## **Access Compliance Report Public Rights-of-Way** (Curb Ramps)

Intersection ID: 11497 Main Street: MARGARET BROWN ST **Cross Street: S IRWIN AV** Location: W **Overall Compliance: No Severity Score:** ADA ID: 0AA1CD1A7D3B Ramp Type: PerpDiag Initial Pass/Fail: Fail 12.5

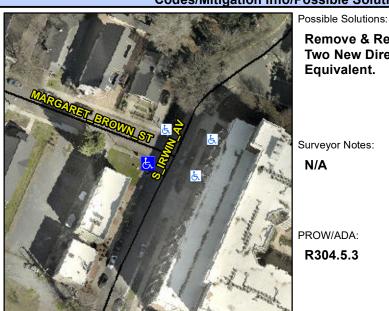
Surveyor Notes: N/A PROW/ADA: R304.5.3

Total Cost: 3200.00 Compliance Description Data Compliance Description Data Yes N/A Ramp Length (in) 60.0 Ramp Slope (%) 6.7 No Ramp XSlope (%) Yes Ramp Width (in) 48.0 5.8 N/A N/A Flare Type LT N/A Flare Type RT N/A N/A N/A N/A Flare Slope RT (%) N/A Flare Slope LT (%) N/A Flare Traversable LT? N/A N/A Flare Traversable RT? N/A N/A N/A N/A **DWS Provided?** N/A Landing Length (in) N/A Landing Width (in) N/A N/A **DWS Contrast?** N/A N/A N/A N/A Landing Slope (%) DWS Length (in) N/A N/A Landing X Slope (%) N/A N/A DWS Full Width? N/A N/A Landing Curb? (Y/N) N/A N/A DWS Offset (in) N/A N/A N/A Shared Landing? N/A **Gutter Ponding?** N/A N/A Gutter Slope (%) N/A N/A Gutter Lip Ht (in) N/A N/A Gutter X Slope (%) N/A N/A Painted X Walk1? No N/A Painted X Walk2? No X Walk 1 Direction To SE X Walk 2 Direction To NE N/A N/A X Walk 1 Width (in) X Walk 2 Width (in) N/A X Walk 1 Slope (%) 10.0 X Walk 2 Slope (%) 3.2 X Walk 2 X Slope (%) X Walk 1 X Slope (%) 1.1 5.8 N/A N/A N/A Ramp inside XWalk2? N/A Ramp inside XWalk1? Road Slope (%) 4.3 N/A Clear Space? N/A N/A Road X Slope (%) 3.0 Clear Space to XWalk (in) N/A N/A N/A N/A Any Obstructions? Storm Grate/Utility Hazard? N/A

Equivalent.

Remove & Replace Curb Ramp With Two New Directional Ramps or
